MILLER RESIDENCE ELEVATION X-SECTION

7709 W. MERCER WAY
 PARCEL NO. 5451300045
 SCALE 1" = 2'
 OWNER: SHANE MILLER
 DATE: NOVEMBER 26, 2019

Summary of Comments on 1912-047-SUB1-PLANS_review.pdf

MILLER RESIDENCE SITE PLAN

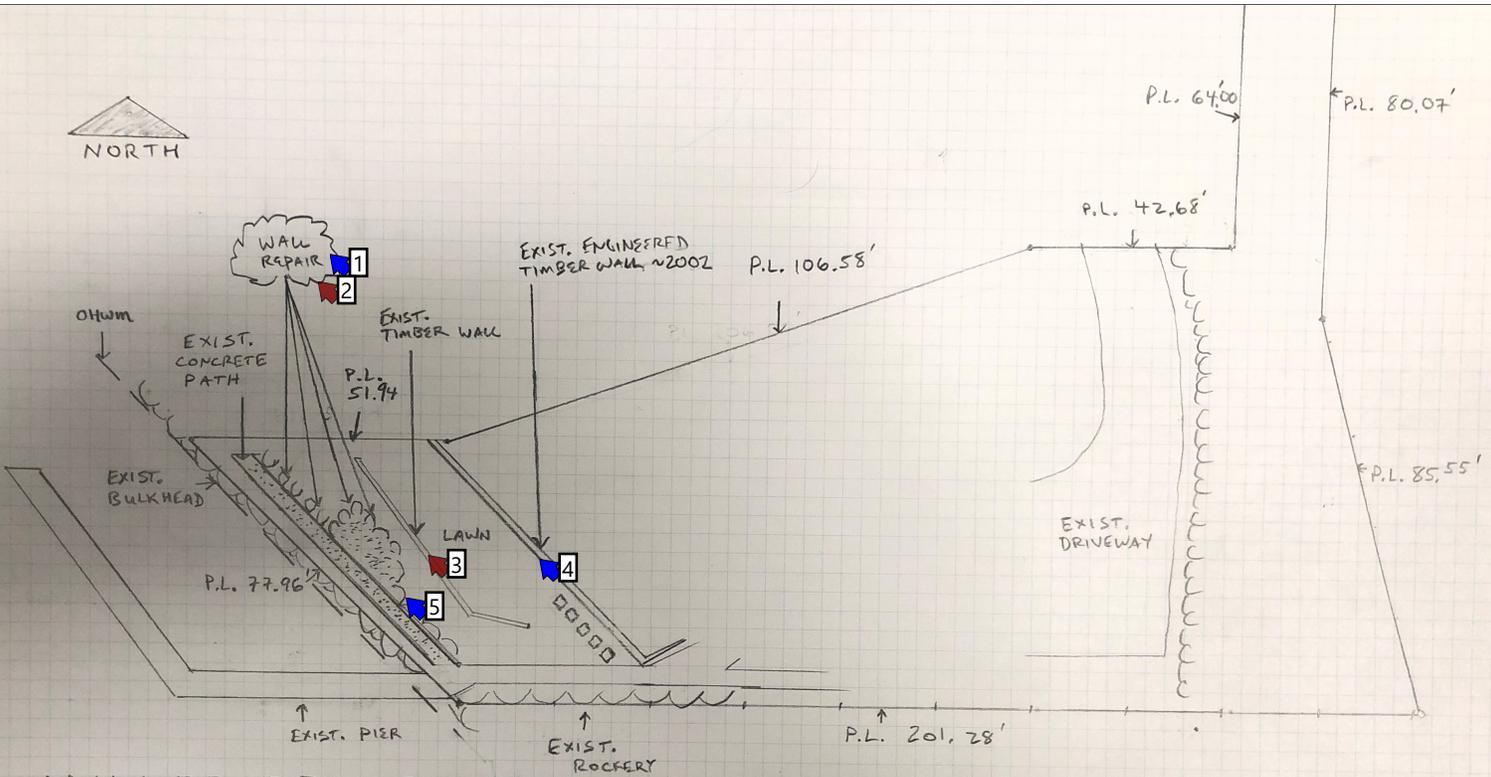
-
-  Number: 1 Author: Building Review (paul.skidmore@mercergov.org) Subject: Comment #1 Date: 12/30/2019 5:47:53 PM
-08'00'
- Maximum allowable permanent backslope, per 2002 geotechnical report, is limited to 2H:1V, and recommended at 3H:1V. This is typical for colluvium soil and shall be confirmed by topographical survey.
-

-  Number: 3 Author: Planning Review (nicole.gaudette@mercergov.org) Subject: Sticky Note Date: 1/2/2020 11:41:00 AM -08'00'
- Please provide the building permit for the timber wall that was removed for the installation of this rock wall. The landscape architect and engineering letters included with this application indicate that a timber retaining wall was removed. However, permits SHL02-013 and 0203-066 that were applied for in 2002 indicates that a rockery existed in the location of the the retaining wall we are currently reviewing.

- This wall is nonconforming because structures are not allowed within 25-feet of the Ordinary High Water Mark of the lake. The permit(s) for the timber retaining wall being removed must be provided to prove that the wall is "legal" nonconforming.
-

-  Number: 4 Author: Building Review (paul.skidmore@mercergov.org) Subject: Comment #1 Date: 12/30/2019 5:47:14 PM
-08'00'
- Provide dimensions locating nearest distance of new rockery from existing bulkhead. Will new retaining wall surcharge the existing bulkhead?
-

-  Number: 5 Author: Geotechnical Peer Review (michele.lorilla@mercergov.org) Subject: Comment Date: 1/2/2020 9:59:00 AM -08'00'
- If the new retaining wall is surcharging the existing bulkhead, the geotechnical engineer shall determine the impact on the bulkhead and provide mitigation and repair recommendations, if necessary.
-

-  Number: 6 Author: Building Review (paul.skidmore@mercergov.org) Subject: Comment #1 Date: 12/30/2019 5:16:27 PM
-08'00'
- How does concrete path provide passive resistance? Note minimum embedment depth of rockery. Indicate how vertical cut in colluvium is achieved. 2002 geotechnical report recommends a maximum temporary cut of 1.5H:1V. Show extent of excavation on the site plan. Note that the cut will be "chasing" the existing slope up the hill.
-

-  Number: 7 Author: Building Review (paul.skidmore@mercergov.org) Subject: Comment #1 Date: 12/30/2019 5:46:27 PM
-08'00'
- The geotechnical engineer letter dated 2018 indicates 70 cypress and 60 arborvitae trees were planted. Please locate these trees on the site plan. Note: it is not appropriate to state that the newer system is "more suitable" than the previous. The new work must meet all current code requirements. Additionally, a statement of risk from the geotechnical engineer is required.
-

-  Number: 8 Author: Building Review (paul.skidmore@mercergov.org) Subject: Comment #1 Date: 12/30/2019 5:23:28 PM
-08'00'
- Provide engineered design of rockery retaining wall, including all surcharges. Provide slope stability analysis for this condition. ARC recommendations are not appropriate in critical areas.
-

-  Number: 9 Author: Planning Review (nicole.gaudette@mercergov.org) Subject: Sticky Note Date: 1/2/2020 11:46:31 AM -08'00'
- How many cubic yards of excavation are required (cut and fill) for the project?
-

-  Number: 10 Author: Planning Review (nicole.gaudette@mercergov.org) Subject: Sticky Note Date: 1/2/2020 11:45:40 AM -08'00'
- A shoreline permit is required for all work within 200-feet of the lake. If you can prove that the retaining wall is legal nonconforming, the shoreline permit may be a Shoreline Exemption permit. If the wall is not legal nonconforming, a Shoreline Variance permit will be required.

- Please see WAC 173-27-040 for more information of the Shoreline permit exemptions.

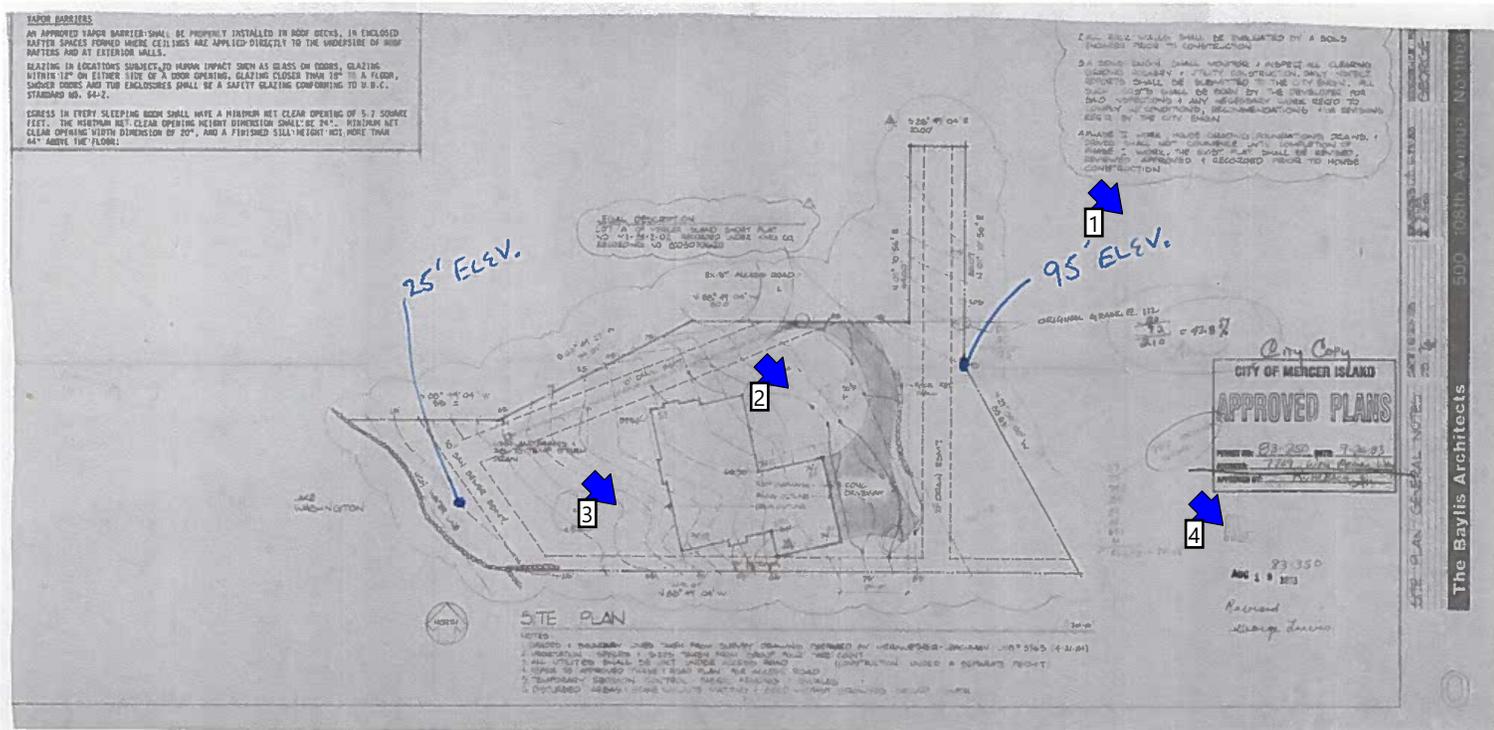
Clarify what is meant by wall repair. There is no record of a permit being issued for a rockery retaining wall. This will be considered as and reviewed as new construction.

Geotechnical engineer to determine cause of wall failure and provide recommendations for stabilization and repair. New soil explorations will be required at the location of the wall to assess the wall failure as well as provide subsurface information for the stabilization and repair. Geotechnical engineer shall specifically address the appropriateness of wall type to retain loose soil conditions as identified in boring B-1 of the 2002 AMEC report if similar soil conditions are encountered in the new soil explorations. Wall design calculations shall be included in the resubmittal as well as stability analyses to verify the stability of the wall. Stability analyses should also assess impact of this lower wall on the stability of the existing features upslope of the wall.

Geotechnical engineer to assess potential undermining of existing timber wall due to lower wall failure and repair activities and provide recommendations for mitigation of impact to existing timber wall or repair recommendations as needed.

Provide a survey by a signed and sealed by a Washington State licensed surveyor. Indicate on the drawing(s) all hardscape, structures, retaining walls, trees, etc. Locate and dimension all hardscape and structures.

Based on aerial mapping, tree(s) have been removed for the construction of non-permitted work. Please note location, species, caliper size of all trees
